UNITED STATES ENVIRONMENTAL PROTECTION AGENCY
REGION V

SUBJECT: Report on December 2, 1987 Meeting with
BASF Corporation and the Michigan DNR

RIVERVIEW SITE
 PROPOSED REPAIR OF
 DRAINAGE SYSTEM
 EXIST. & PROPOSED REPAIR SECTIONS

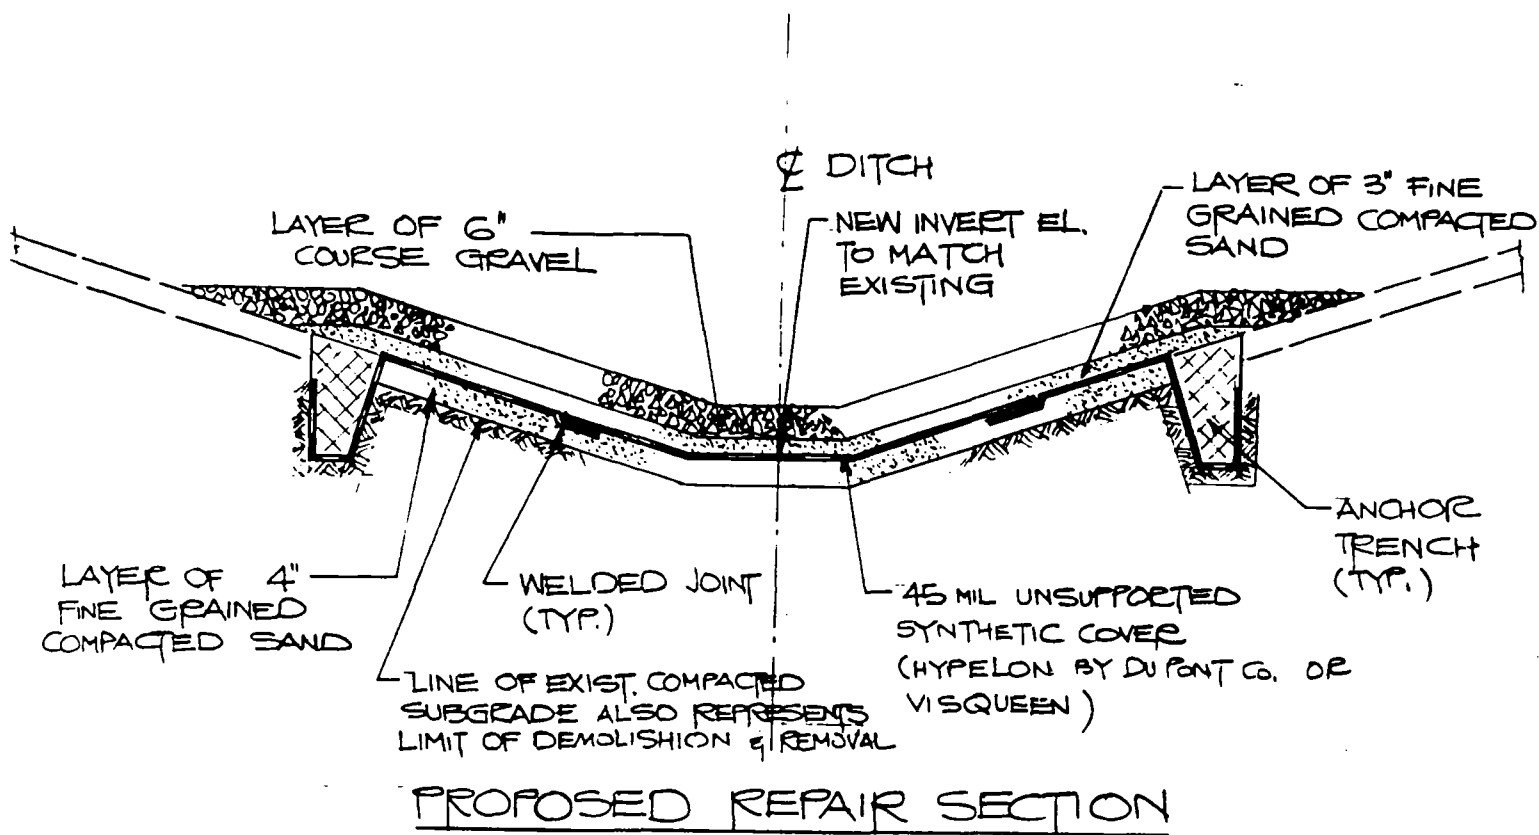
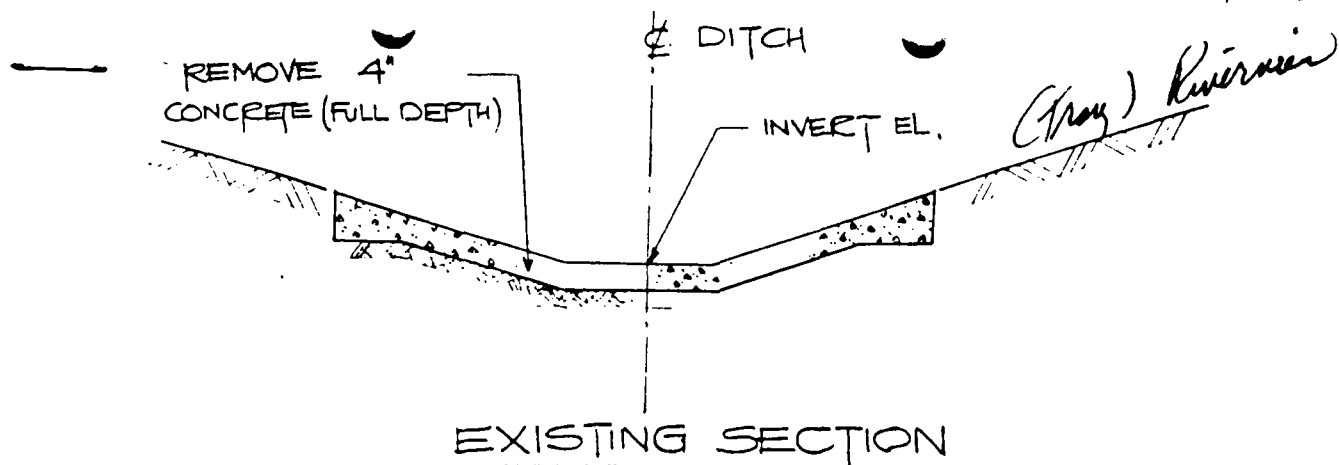
To address the seepage problem, BASF proposed to remove the concrete ditch, and replace it with a 45 mil. synthetic liner. Compacted sand would be used over and under the liner to protect it; about six inches of gravel would be laid over the top layer of sand. The new liner would be wider than the existing concrete ditch, to reduce the chances of seepage over the top. Attachment 2 of this report is a cross-section of the proposed changes to the ditch.

For stability, the concrete ditch will be left in place near the water's edge. The new liner will connect to the concrete something like this:

BASF believes this design will, for the most part, keep the groundwater on the site and prevent seepage to the main ditch. We responded to the proposal by saying, first of all, we would need to check back with appropriate people in Lansing and Chicago before we could fully endorse this change. Secondly, we indicated that even if we go ahead with this change, we would still like to see sampling data on:

- a. Was the installation of the new liner successful at stopping seepage?
- b. Is seepage a problem at the other two ditches?
- c. Is stormwater runoff from the site contaminated?
